<b>Address:</b>	<b>Euston Approaches Worksite and Adelaide Road Worksite</b>	
<b>Application Number(s):</b>	2019/4700/HS2	Officer: Ben Farrant
<b>Ward:</b>	Belsize, Haverstock, and Regent's Park	
<b>Date Received:</b>	16/09/2019	
<p><b>Proposal: Lorry routes to and from the Euston Approaches and Adelaide Road worksites associated with works for HS2.</b></p> <p><b>Main works activities include: Construction of the Park Village East retaining wall, portal and high-speed dive unders including the installation of ground anchors; Removal of excavated material from the station approach, tunnel portal and headhouse works; Construction of the decks over the high-speed dive under and railway south of Mornington Street Bridge; Construction of the west and east side retaining wall around Hampstead Road Bridge; Extension of Hampstead Road Bridge as well as associated utilities and highway works; Support the movement of plant and material down into the Euston approach railway cutting; Support the removal of excavated material generated in the railway cutting; Construction of Adelaide Road vent shaft and single storey headhouse building; and all other activities for the purposes and in connectio

Figure 4: Adelaide Road worksite – Route A.

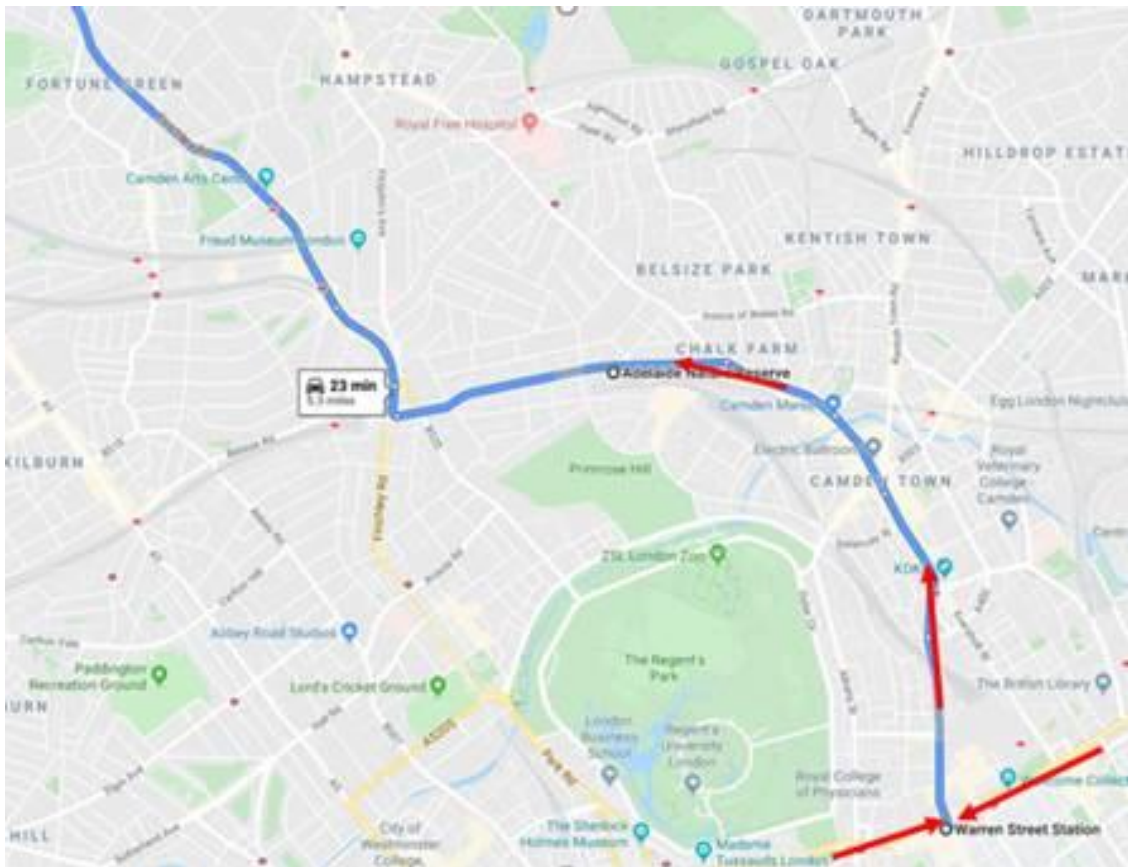
- 8.7 It is the view of officers that Route A ought to be modified to reduce prejudicial effects on road safety.
- 8.8 Officers consider that it is unacceptable for construction traffic to follow a route northwards along the north section of Camden High Street from the station to the lock and then northwards up Chalk Farm Road. The carriageway here is narrowed to a single lane, although the pavements have been widened, the amount of footfall in this tourist hotspot at times exceeds what can be safely accommodated on the footway and pedestrians frequently spill into the highway.

- 8.11 Pedestrian counts undertaken in 2019 (by Camden Town Unlimited) show there is an average of 26,121 pedestrians per day on weekdays walking along the eastern side of Camden High Street, north of Camden Town station. Saturdays experience even higher pedestrian numbers, with an average of 41,617 per Saturday in 2019. There were over 30 days in 2019 where pedestrian counts were over 40,000 (Monday-Saturday) and several days exceeding 45,000, while the surveys also show that the number of days where pedestrian counts exceed 40,000 is increasing annually.

8.48 It is the view of officers that the arrangements put forward by HS2 Ltd in relation to routes to and from the Adelaide Road worksite ought to be modified to reduce prejudicial effects on road safety and that they are reasonably capable of being so modified by following Route D.

Figure 7: Euston Approaches Phase 1 lorry routes

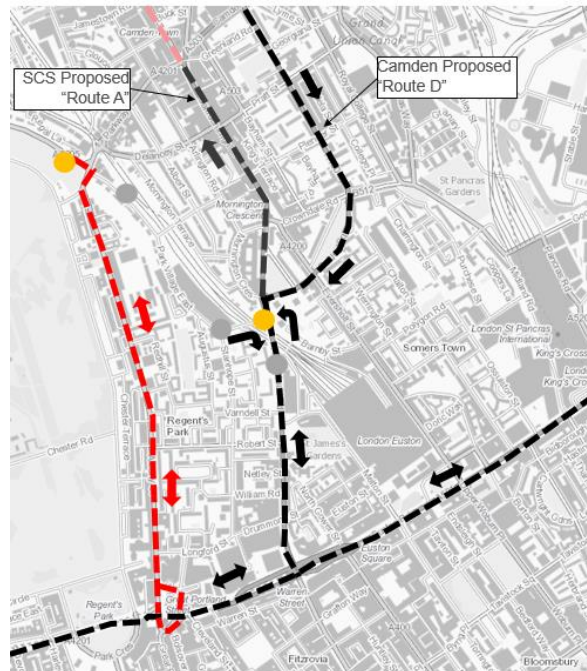
- 3.25 It is noted that for Phase 1 the plans provided do not clearly show the use of access point 1, despite being used. For phase 1 this is for 40T+ vehicles only.

Figure 9: Euston Approaches Phase 3 lorry routes

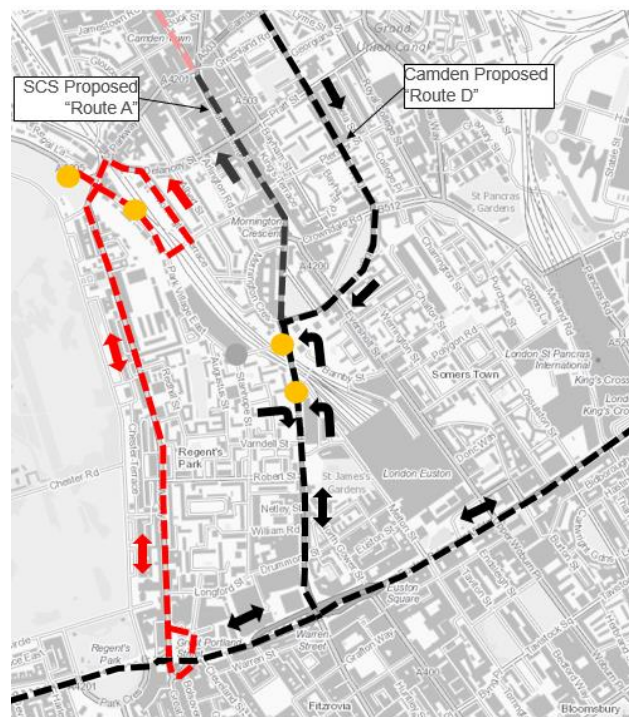
- 3.41 It is noted that for Phase 3 the plans provided do not clearly show the use of access point 1, despite being used. For Phase 3, this is for 40T+ vehicles as well as the egress point for vehicles accessing via gate 2.

Figure 13: Adelaide Road worksite – Route B access

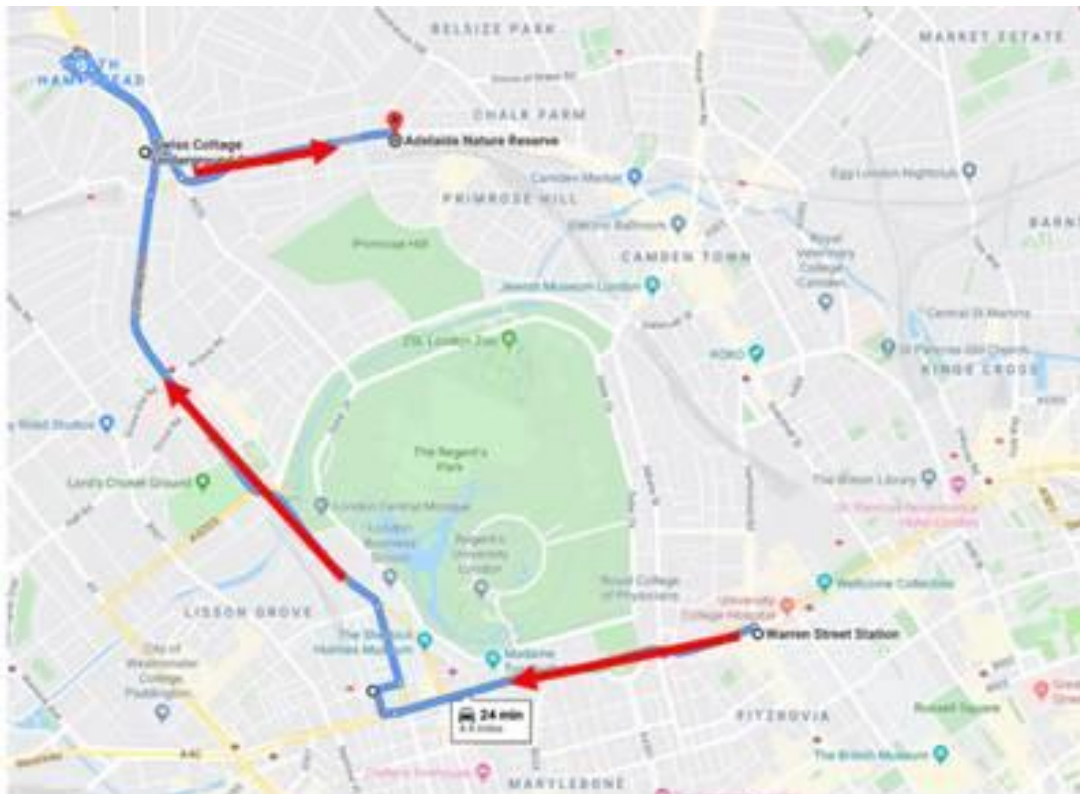
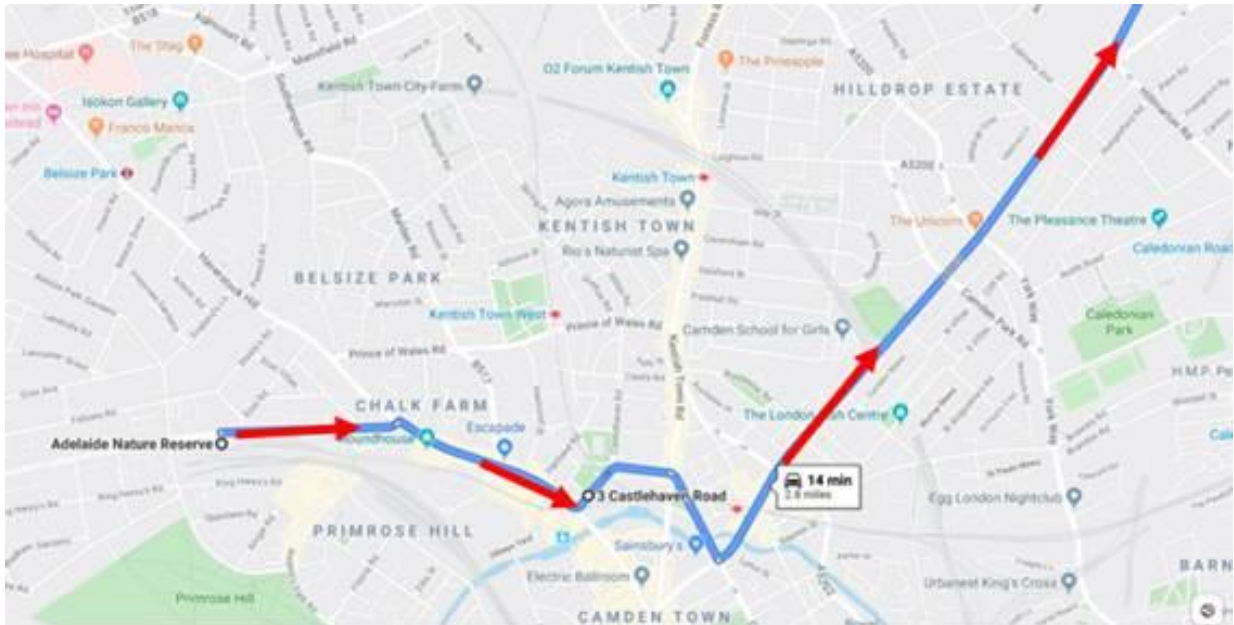
8.34 Route B was discounted as TfL have recently consulted on and are planning to implement the prohibition of a left turn from A400 Camden Street to A503 Camden Road (TLRN). This would mean vehicles are unable to follow the proposed Route B as this left turn would be required as part of the route.

Figure 14: Adelaide Road worksite – Route C

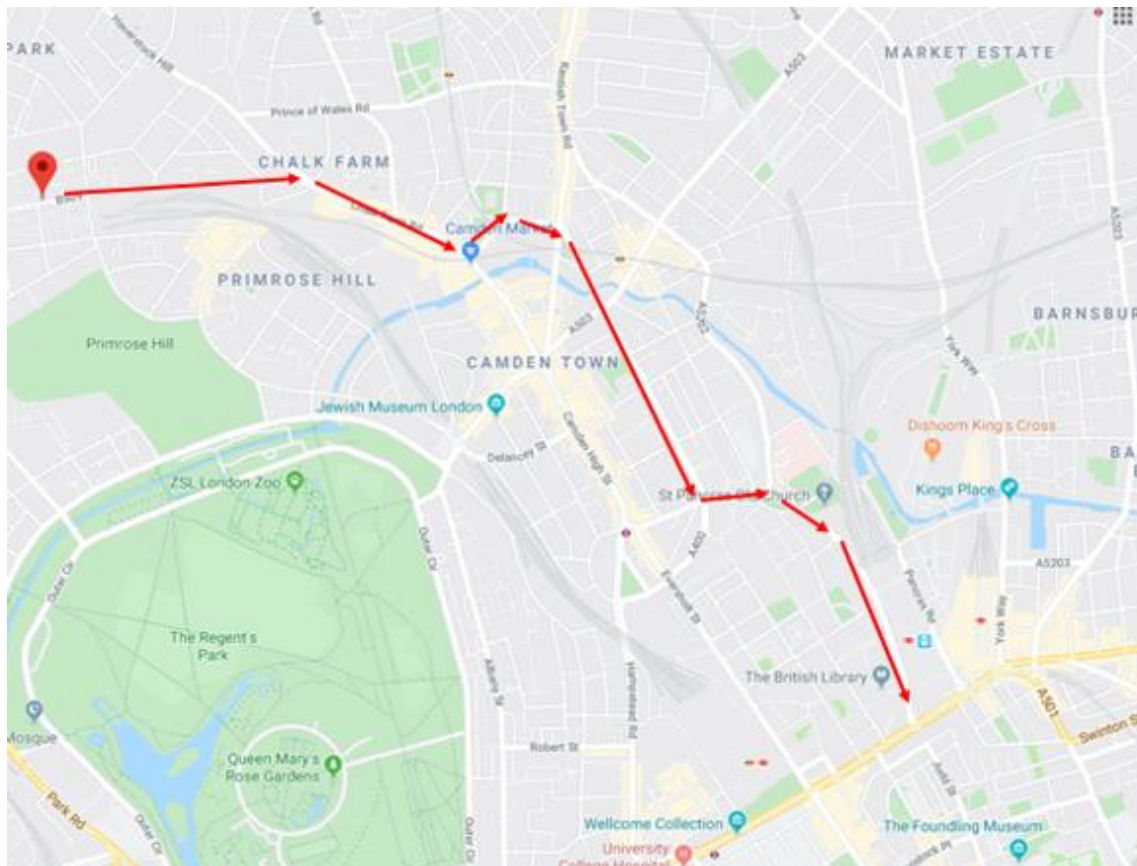
- 8.37 Route C is considered preferable as an egress route, as it avoids the heart of Camden Town Centre with the ensuing issues of safety and amenity issues to the Town Centre mentioned above. It does not have the high footfall levels of Camden High St and has lower casualty risks, evidenced by lower casualty figures than Camden High St route. Route C does provide a swift route on to the TLRN at Camden St, which is a generally agreed principle with HS2. However, as HS2 have highlighted, it does pass a number of schools and for this reason the Council would seek a condition being used by HS2 construction vehicles to use best reasonable endeavours using this egress route during school pick up and drop times by planning condition.

Figure 15: Adelaide Road worksite – Route D

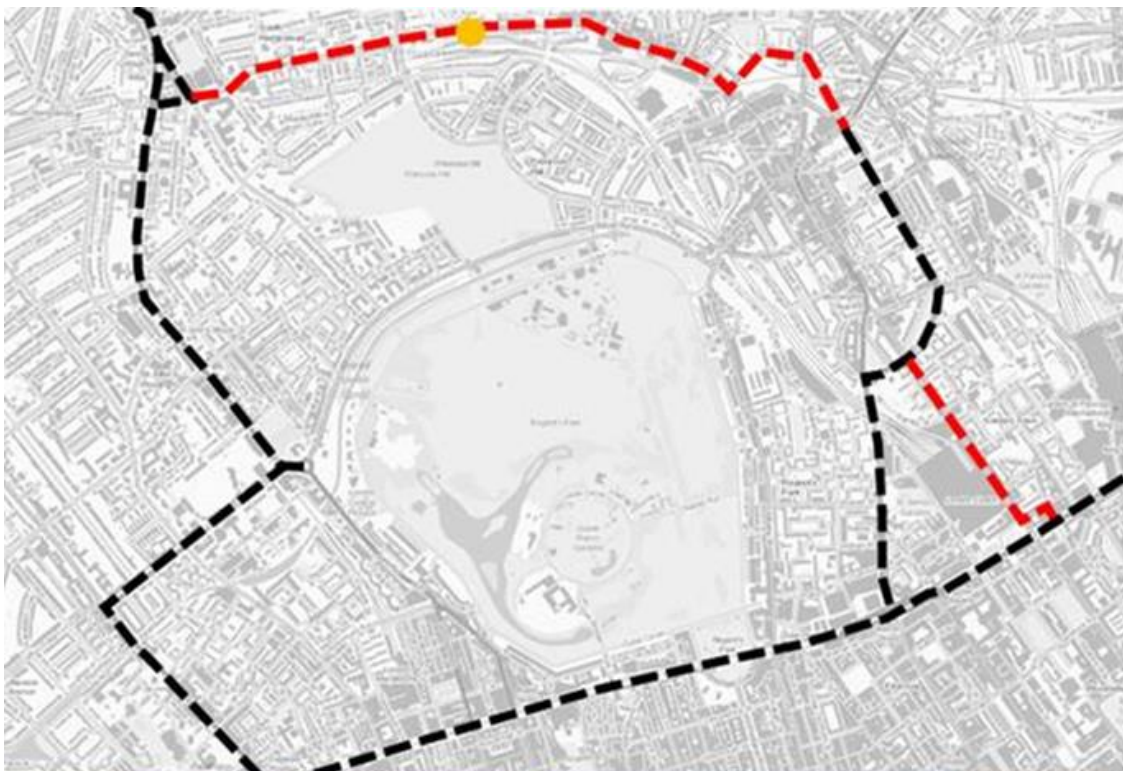
- 8.39 Vehicles using this proposed egress route route would avoid Camden High Street in its entirety. Thereby avoiding the heart of Camden Town Centre and the problems set out above in relation to road safety.
- 8.40 The Council's records of accidents on this route are significantly lower than route A, as one might expect, given that it avoids Camden High St in the heart of Camden Town Centre with its high footfall and more likely conflicts between pedestrians and cyclists with motorised vehicles. The map below shows the differences in Route A and Route D.
